PHOENIX HOMES WHITETAIL RIDGE WTR4-134 SPRINGFIELD R W/ SUNROOM

Re: Proposed Single Family Dwelling, 112 Frank Fisher Crescent, Lot # 134 White Tail Ridge, Almonte, Kollaard Associates File # 230020

With regard to structural issues only, Kollaard Associates has reviewed the following drawings:

Basement Plan – Pages # 2:

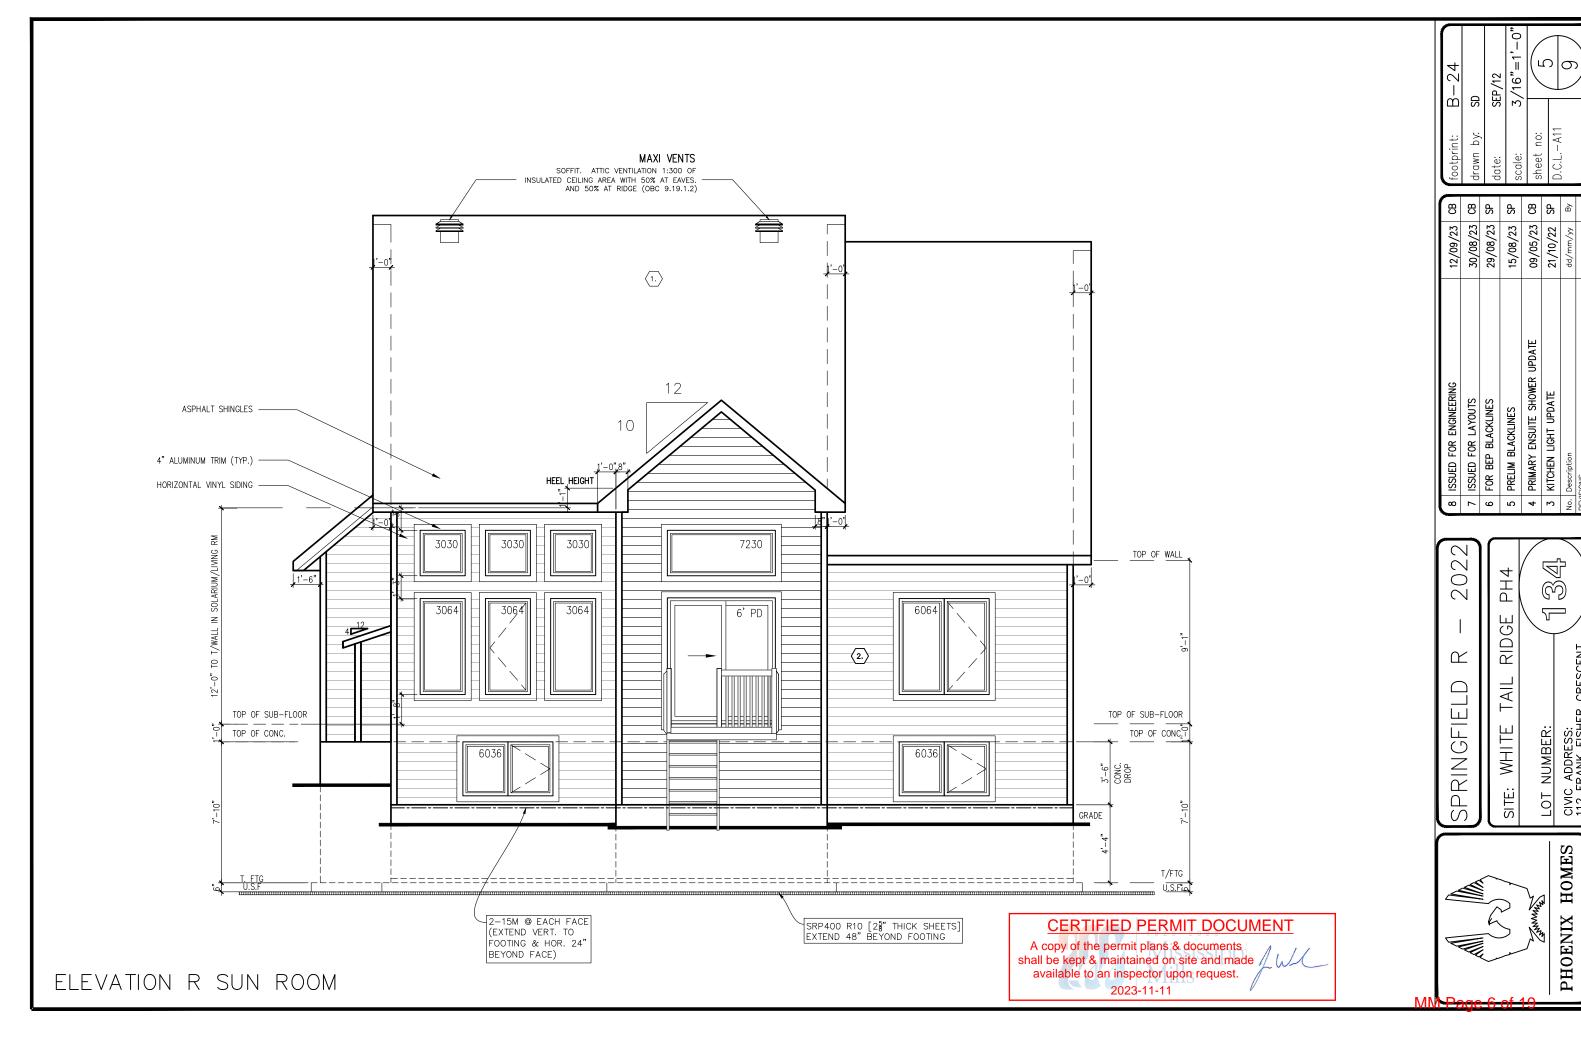
- 5. It is the opinion of Kollaard Associates that the proposed steel beams, steel posts and built-up wood posts shown on Phoenix Homes Pages # 2 are adequate.
- The front porch slab reinforcement described on Phoenix Homes Pages # 1 is adequate.

- 7. The proposed 7'-10" high foundation walls conform to 2012 OBC Table 9.15.4.2.A. ensuring the grade difference between the basement slab and the exterior finished grade (including the garage slab) does not exceed 7'-6½".

- 8. The reduction in foundation wall thickness for the installation of the masonry veneer is to be as per 2012 OBC 9.15.4.7.(2).
- 9. The foundation walls at the bottom of the window openings that exceed 47¼" in width (or the sum of the widths of the window openings exceed 25% of the length of the wall) are considered to be laterally unsupported as per 2012 OBC 9.15.4.3. The reinforcement around the window openings noted on Phoenix Homes Sheet # 2 is adequate to withstand the lateral earth pressures.

- 10. The proposed stepped down foundation walls with framed knee walls above conform to 2012 OBC Table 9.15.4.2.A. ensuring the grade difference between the basement slab and the exterior finished grade does not exceed 3'-11".

- 12. The strip footings and proposed interior pad footings shown on Phoenix Homes Page # 2 and noted on Phoenix Homes Page # 1 are adequate.
- 13. Floor joist design, flush LVL beams/lintels within the floor structure and LVL lintels are by the manufacturer. The posts supporting the flush LVL beams/lintels shown on Phoenix Homes Pages # 2 are adequate.

Ground Floor Plan - Pages # 3:

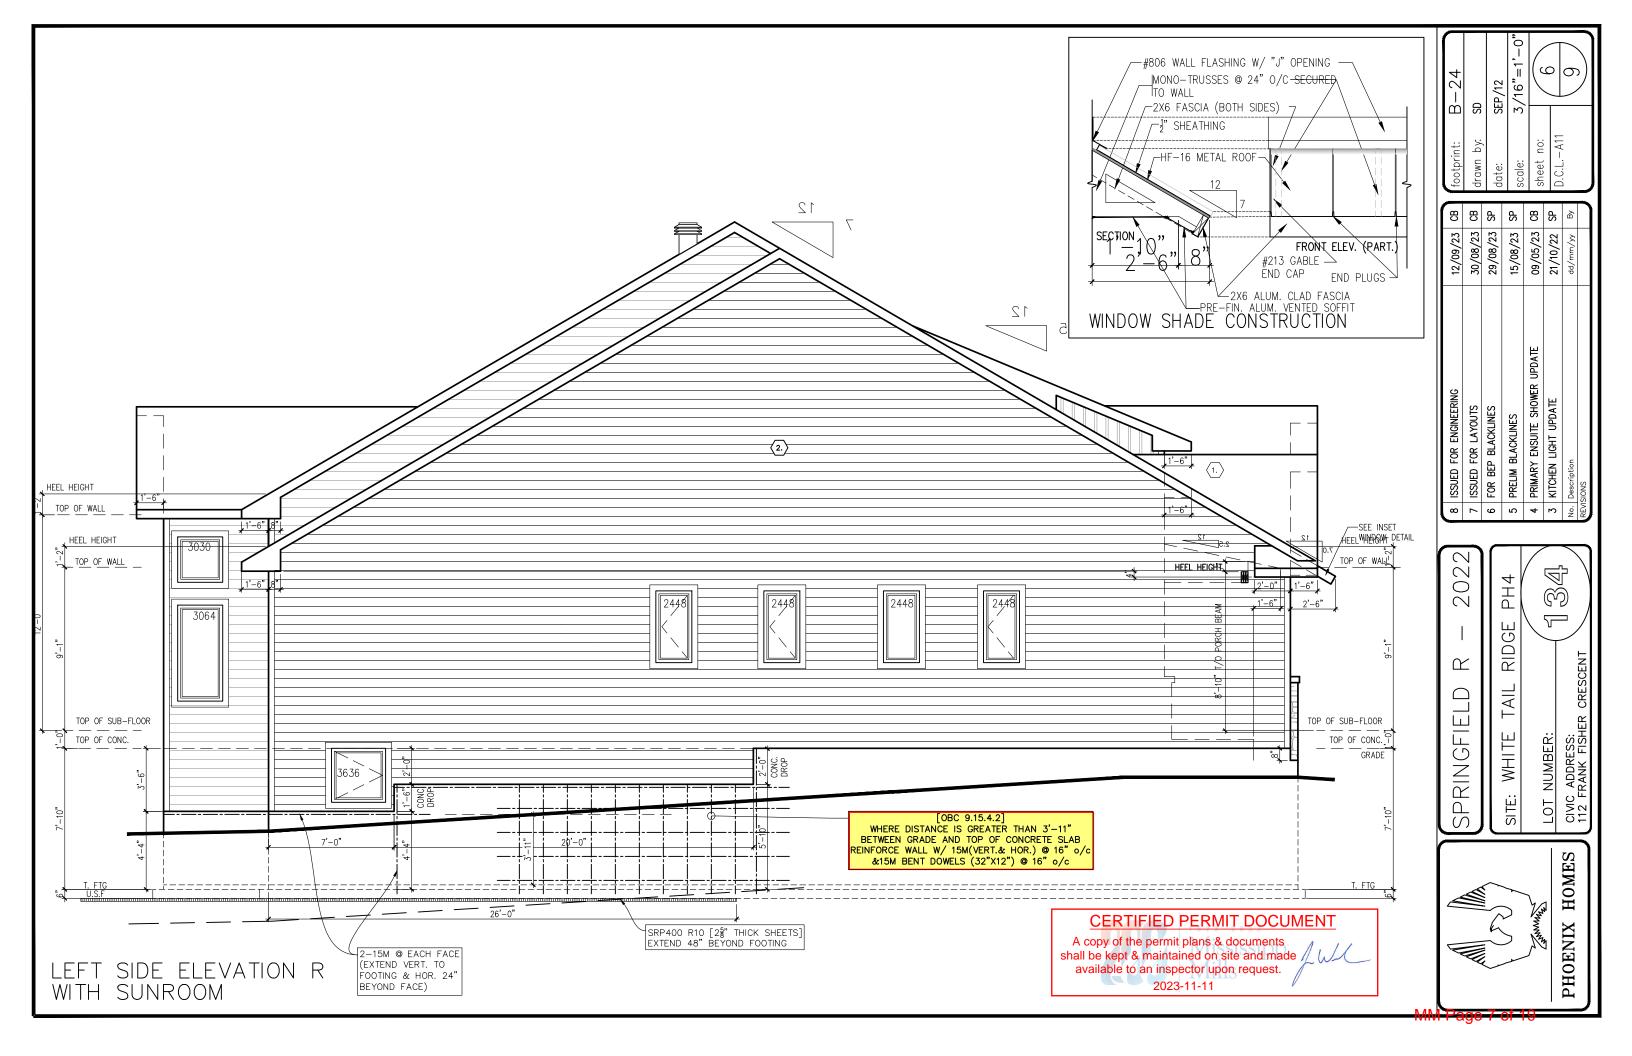
- 1. It is the opinion of Kollaard Associates that the proposed beams, lintels and supporting posts shown on Phoenix Homes Pages # 3 are adequate.
- 2. The proposed tall wall construction (including posts supporting lintels within the tall wall) noted on Phoenix Homes Pages # 1 is adequate.
- Posts supporting girders may consist of built up 2x6 posts as indicated on Phoenix Homes Pages # 3
 and are laterally supported by plywood or OSB sheathing (i.e. posts form part of sheathed exterior
 walls unless noted).
- 4. Truss design is by others.
